Addendum Planning Committee

Planning Committee - Wednesday, 8 June 2022, 7.30 pm

ADDENDUM

<u>PLANNING APPLICATION: 21/03303/F - Titan House Crossoak Lane Salfords</u> Surrey RH1 5EX

Drawing No.: 2105-PL-0020

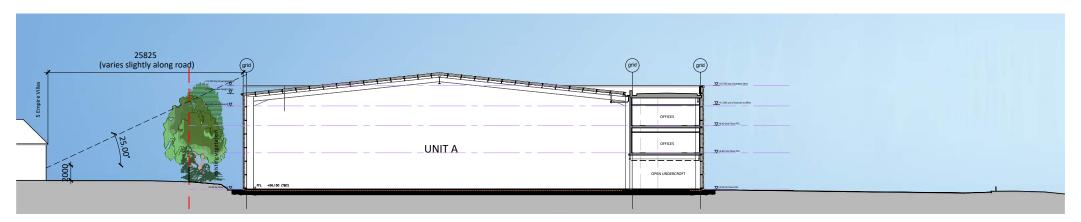
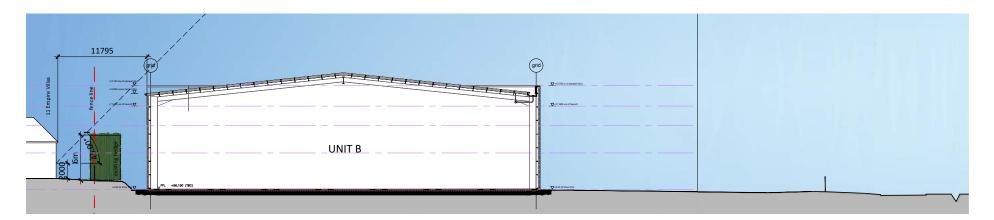
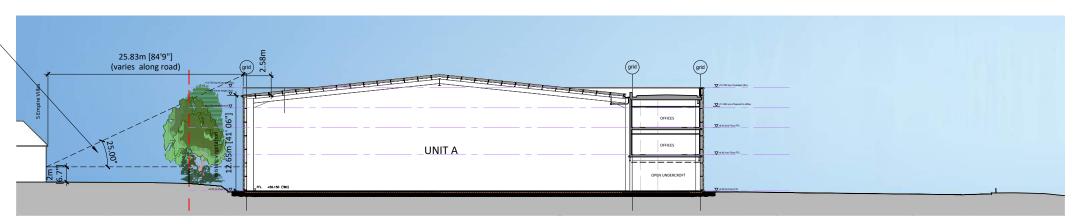
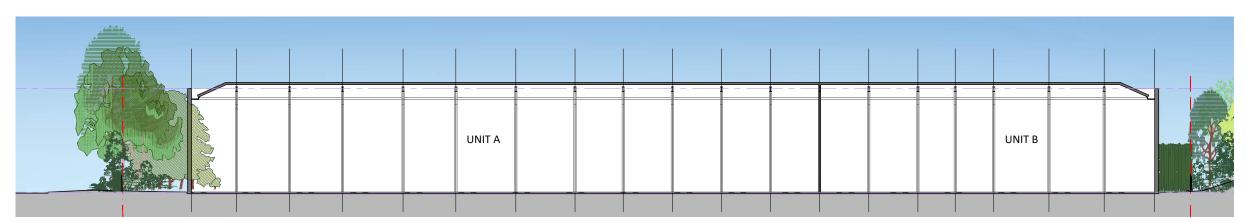
P2	Rear parapet dropped and outboard gutter added	04.04.2022	WR	WF	
P1	Issued for Planning Approval	10.12.2021	WR	WF	
Rev	Notes	dd.mm.yyyy	Ву	Aut	
PLANNING					
0	2500 7500 10000 12500 1750 CALE BAR IN mm	0 20000 22	2500	2500
